# **TRANSPORTATION ENGINEERING DESIGN STANDARDS EXCEPTION REQUEST**

FOR  
**Red Rocks Valley**  
South Camp Road, ½ mile west of Monument Road

RE: *Design Exception #06-07, Red Rocks Valley Subdivision, PP-2006-2007  
TEDS Exceptions for Limited Street Lighting and Cul de Sac Length*

## DESIGN EXCEPTION #06-07

**TEDS Exception Request  
Desired Plan**

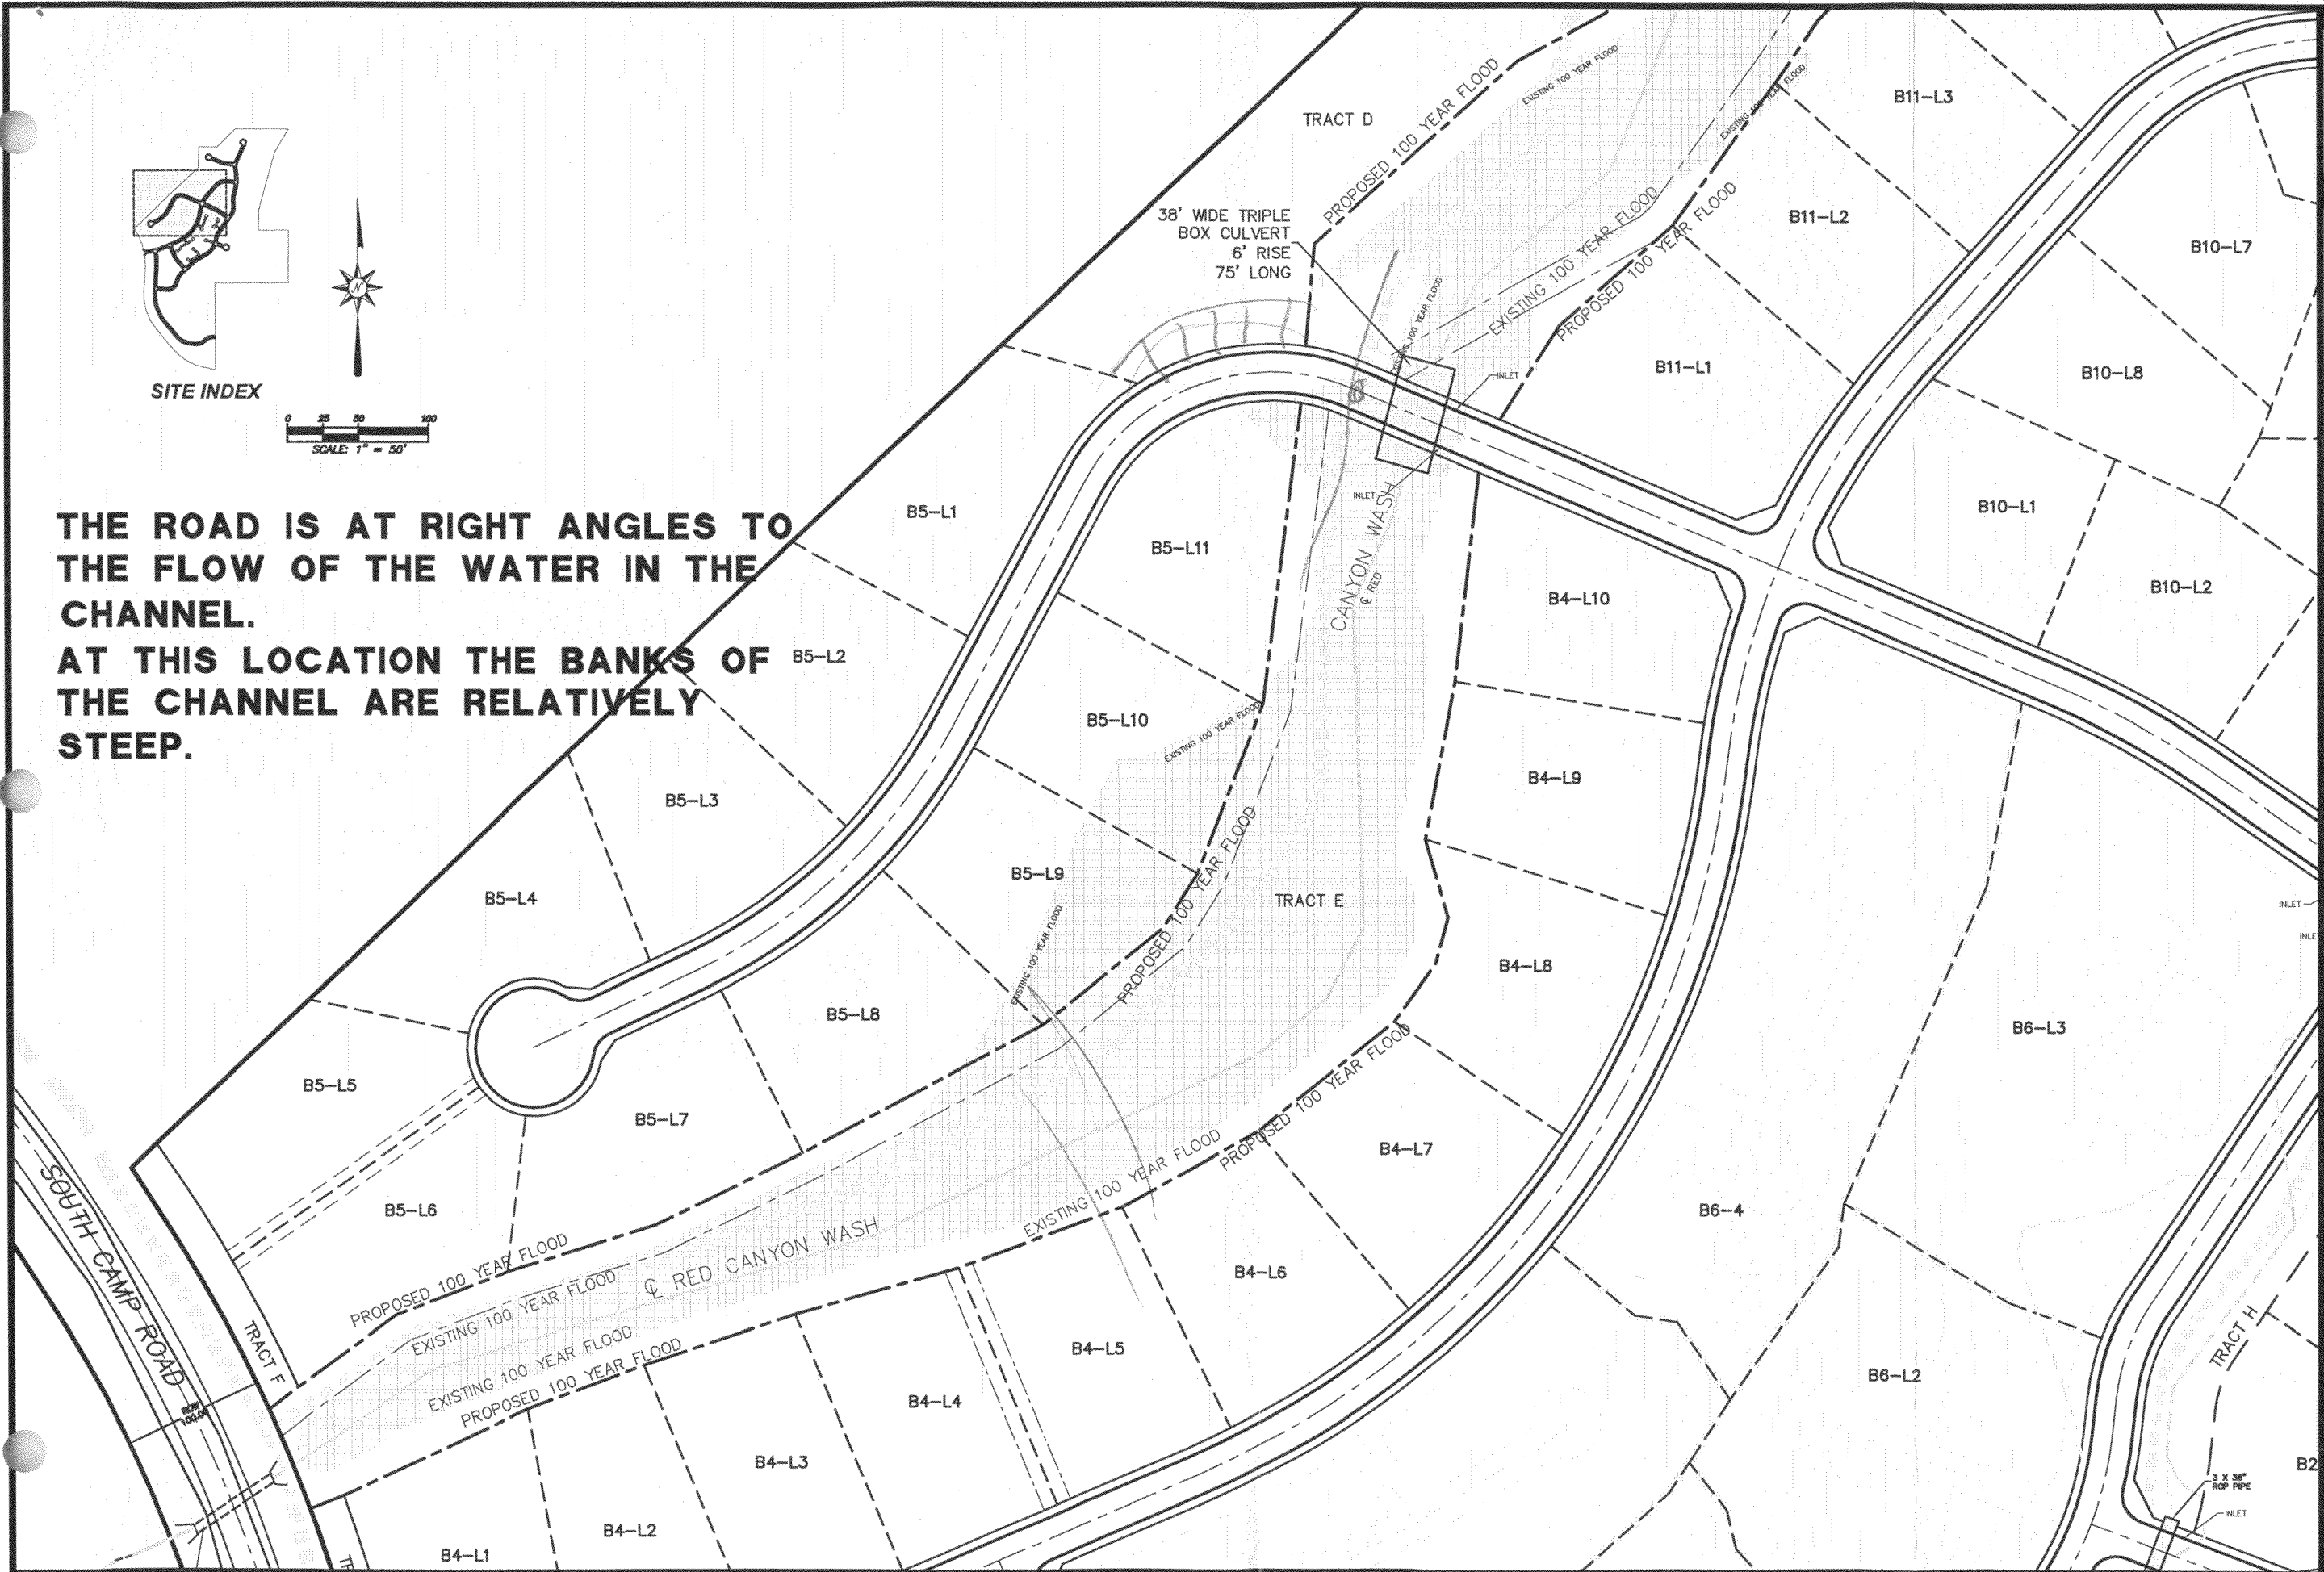
**THE ROAD IS AT RIGHT ANGLES TO THE FLOW OF THE WATER IN THE CHANNEL.  
AT THIS LOCATION THE BANKS OF THE CHANNEL ARE RELATIVELY STEEP.**

**#1 Maximum Cul de Sac Length:** The proposed cul de sac length is 1118' where the TEDS maximum is 750'.

Yes, there is another alternative that would create two shorter cul de sacs that would meet TEDS. They included this in their request. It makes street drainage and sanitary sewer alignment more complicated. The channel is more impacted by the street crossing in this location since the existing banks aren't as steep.

# ALTERNATE 1

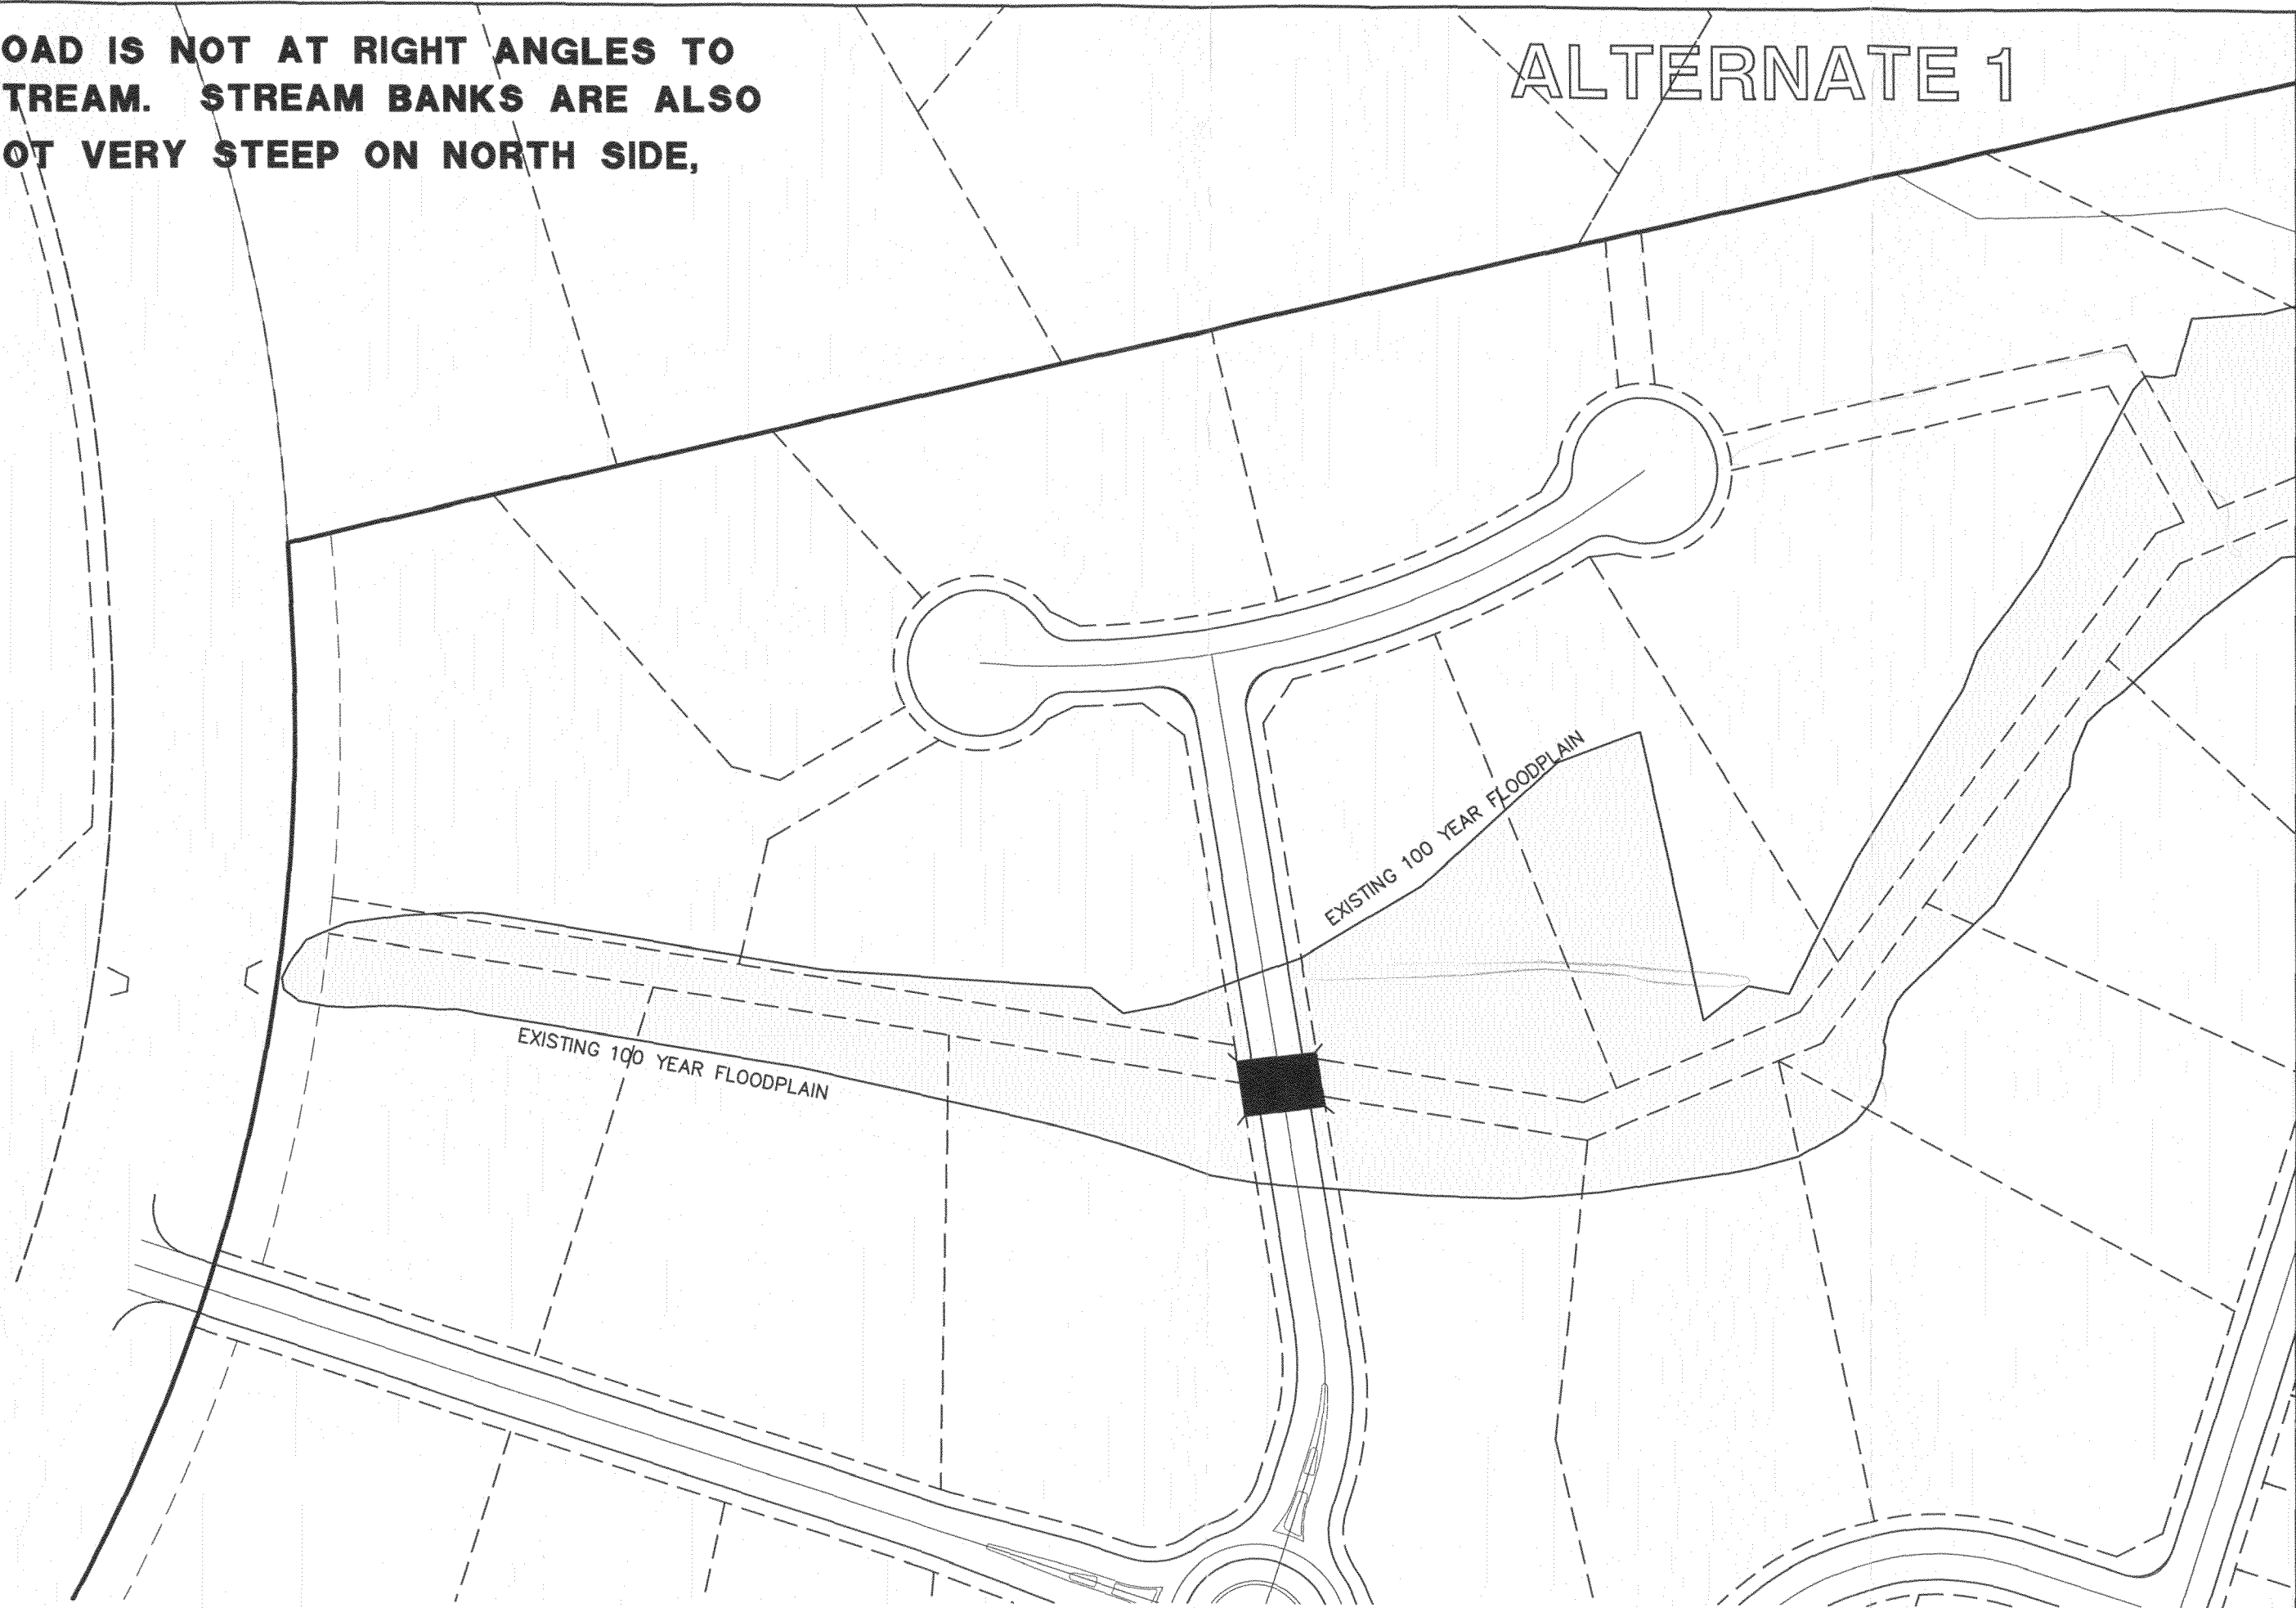
Alternate 1 crosses the channel at a different place and then there is a “T” intersection that goes to two cul-de-sacs. This would meet TEDS standards, however it should be noted that there are approximately the same number of lots that essentially are off of one egress. The only difference is that there is an “intersection” beyond that egress. One problem that we had with this layout is getting sanitary sewer to this part of the project. Gravity sewer has to come in from east to west, from the Red Canyon Channel. The sewer is required to be in a tract and there would be some difficulties with the roughness of the terrain over that tract. Another difficulty was with getting the storm drainage from this area to the Red Canyon channel.

ROAD IS NOT AT RIGHT ANGLES TO  
STREAM. STREAM BANKS ARE ALSO  
NOT VERY STEEP ON NORTH SIDE,
